DRAFT SAN TIN TECHNOPOLE OUTLINE ZONING PLAN

REPRESENTATION BY
HONG KONG INSTITUTE OF URBAN
DESIGN
MAY 2024

总要来一次南头古城

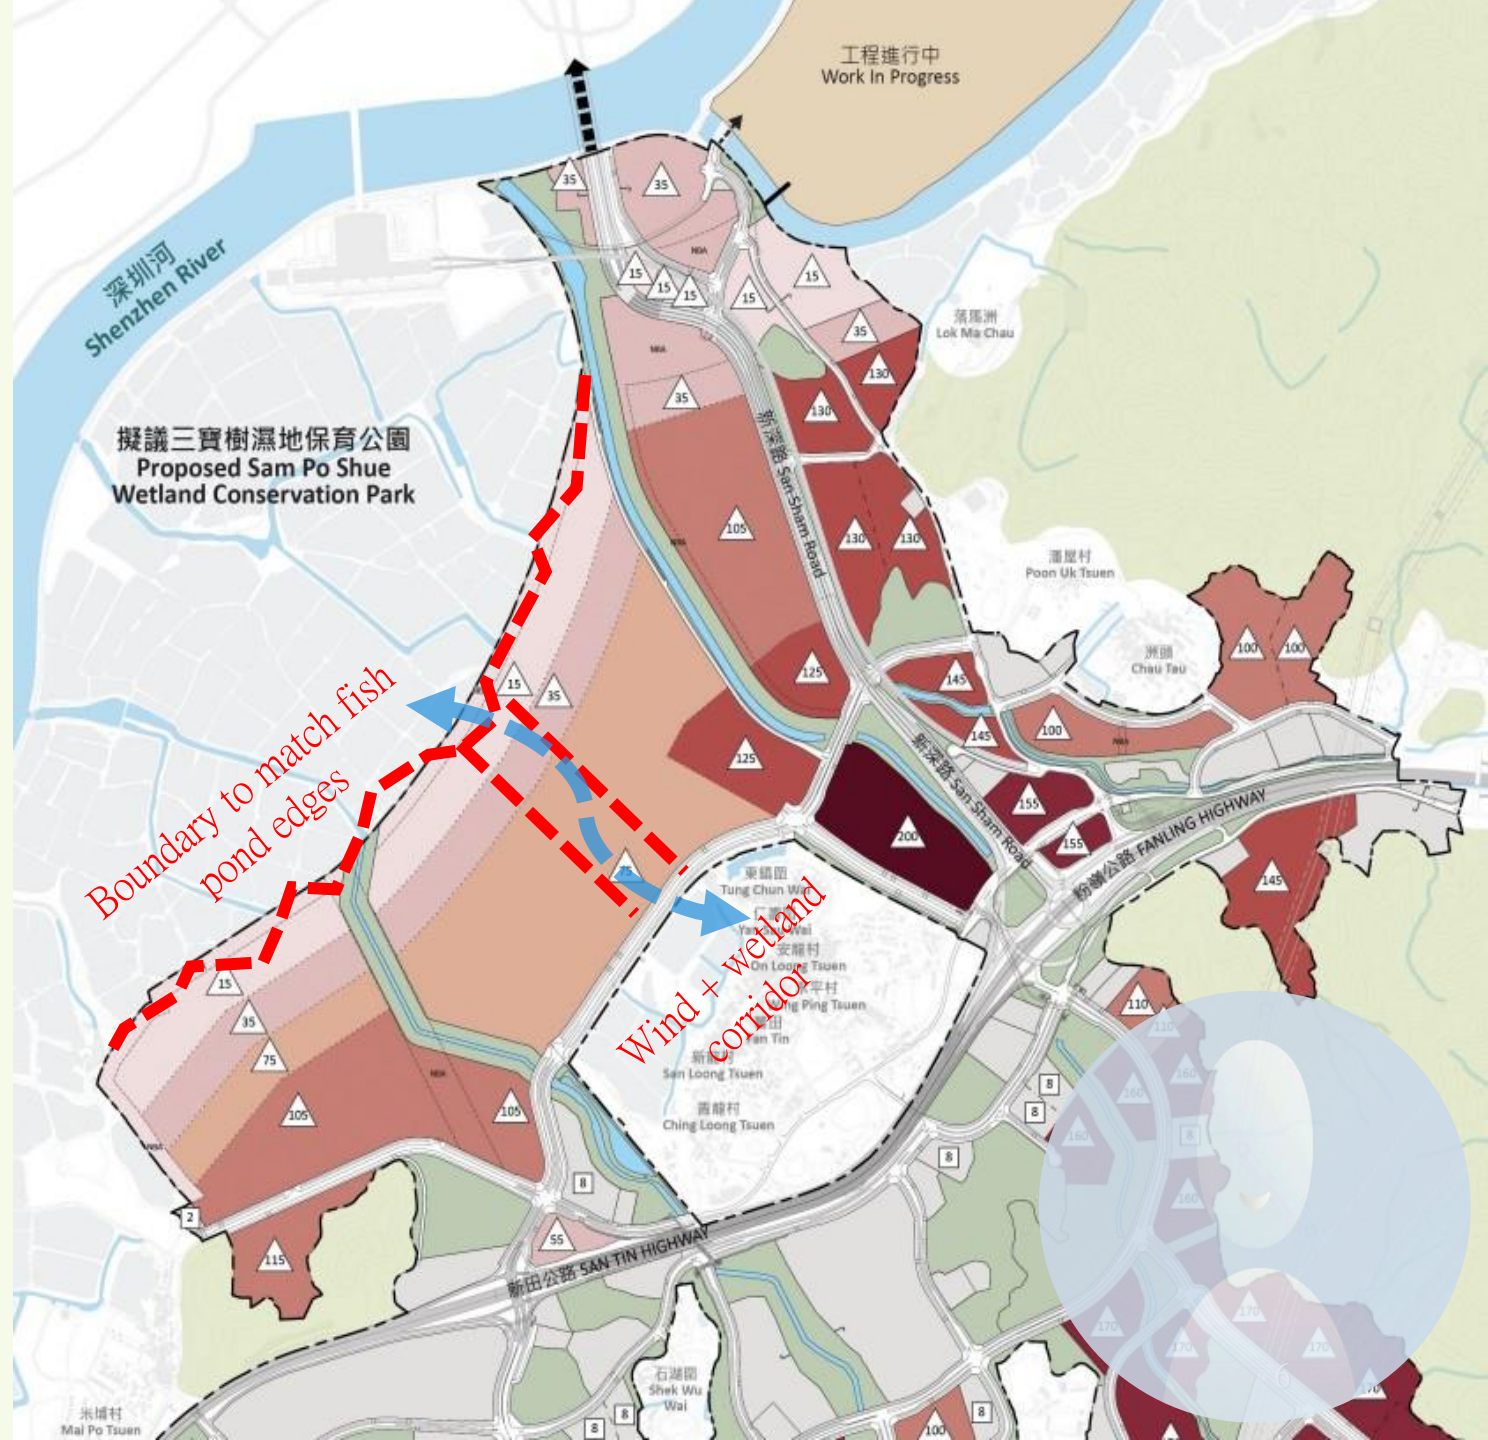
- Many “Villages inside City”（城中村）on the Mainland have been into vibrant cultural recreational, RDE and tourist destinations. They are usually results of government facilitated private enterprise and villager cooperative efforts.
- Nantou City（南頭古城）is a very successful example just across the border.

- the government shall review the possibility of urban/village integration
- indicate in under “Planning Intention” of “V” zone that comprehensive redevelopment into cultural, retail & tourist destinations along with residential uses
- add “Exhibition or Convention Hall” and “Place of Recreation, Sports and Culture” to column 1, and the removing of the wordings of (Holiday House only) from Hotel use on column 2.

4.0 | DRAINAGE CHANNELS FOR RECREATION USES

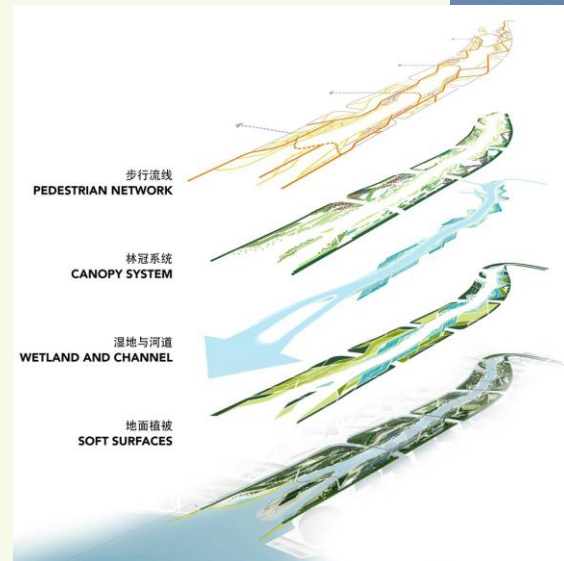
- The two drainage channels cutting across the I&T Park are uninteresting
- They are of more than 1km and 2km in length but not planned alongside with any recreational uses, parks or nodal points
- Cheonggyecheon Restoration in Seoul has shown the world how nice a drainage channel can be.

- The government shall revisit the design of the two channels and to see if any recreational uses can be incorporated
- These two drainage channels shall also be designed integrative with the I&T Park on both sides of the channel

6.0 | AN URBAN DESIGN GUIDELINES FOR FUTURE I&T PARK

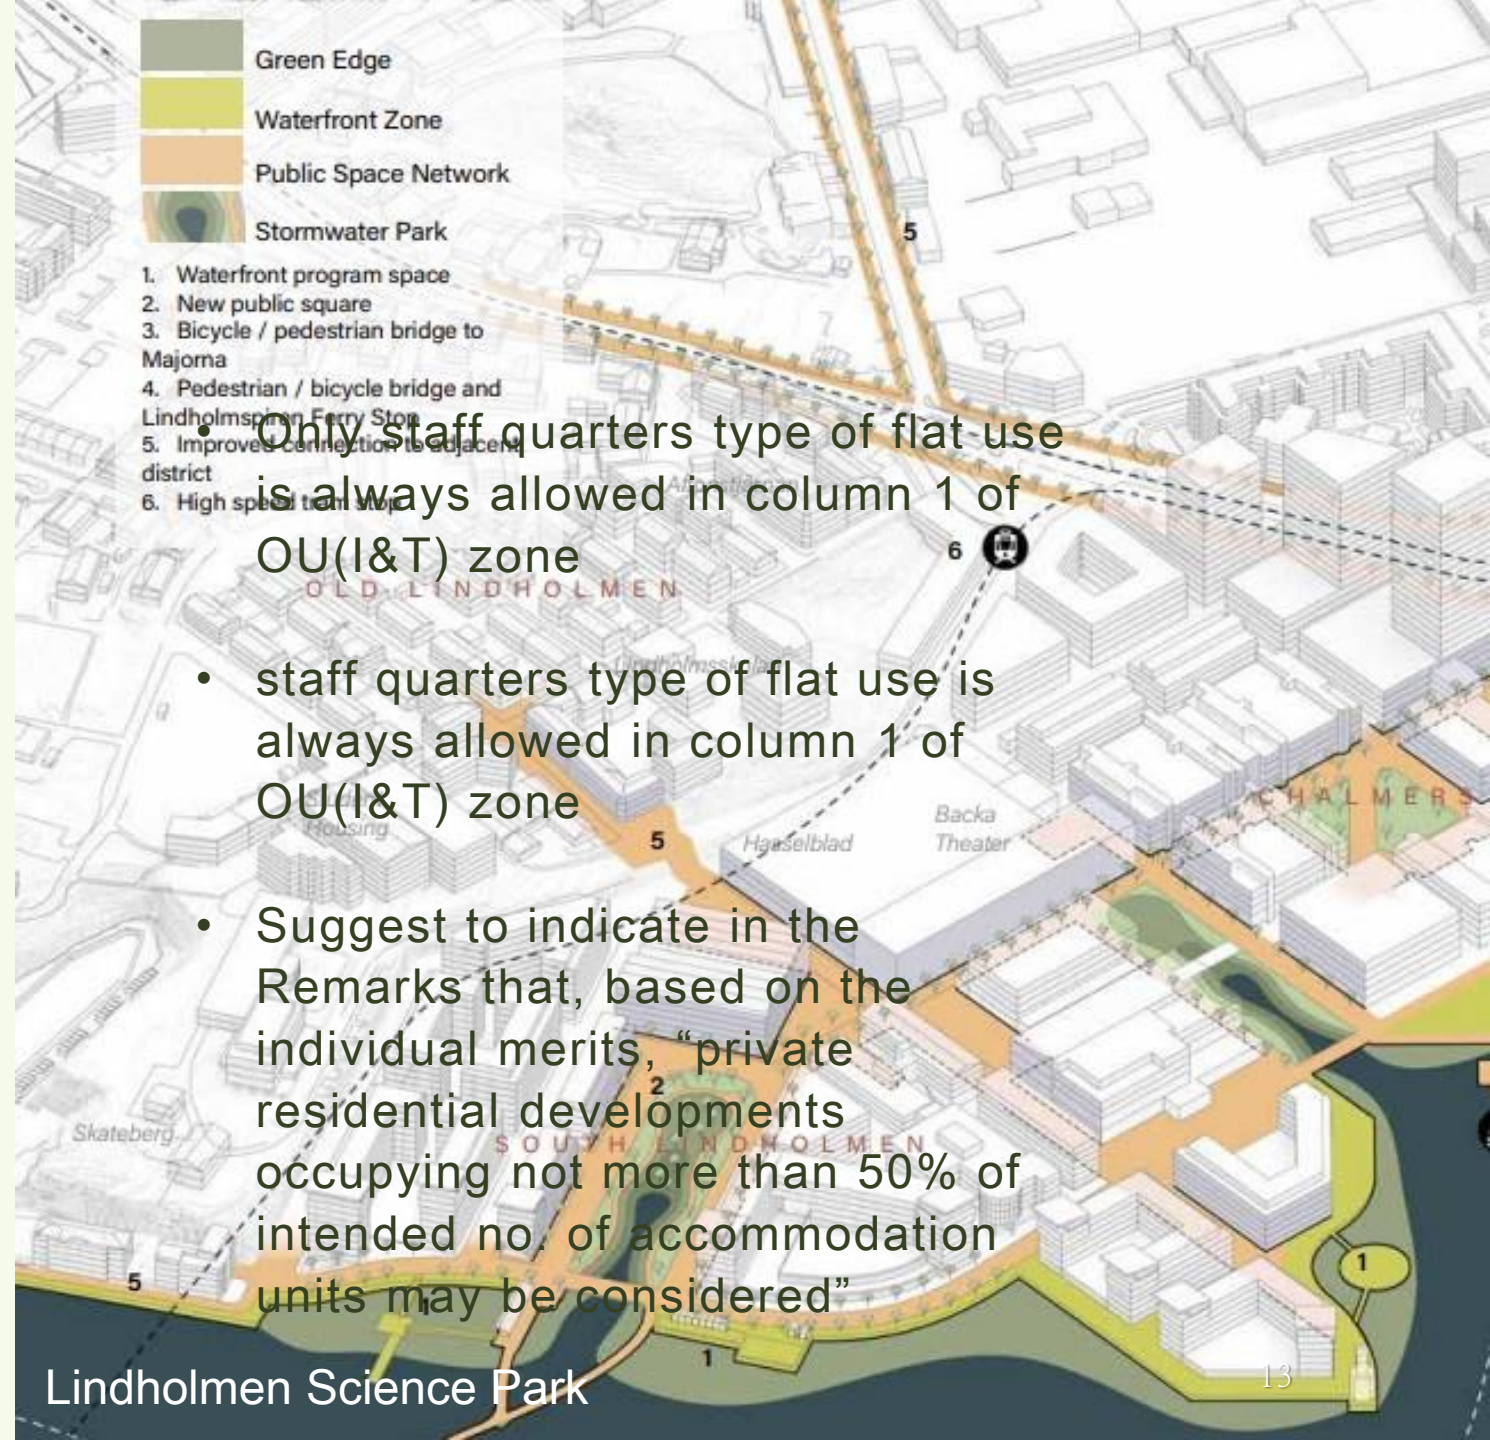
- There is no guiding urban design principle for the I&T Park which is of half the size of Tin Shui Wai.
- For within the IT Park, there should be a framework for pedestrian connection, open spaces and blue and green network, interfacing with the other planned urban areas and village
- We suggest to include in the Remarks to OU(I&T) zone that a set of urban design guidelines shall be established before site formation for the I&T Park to begin
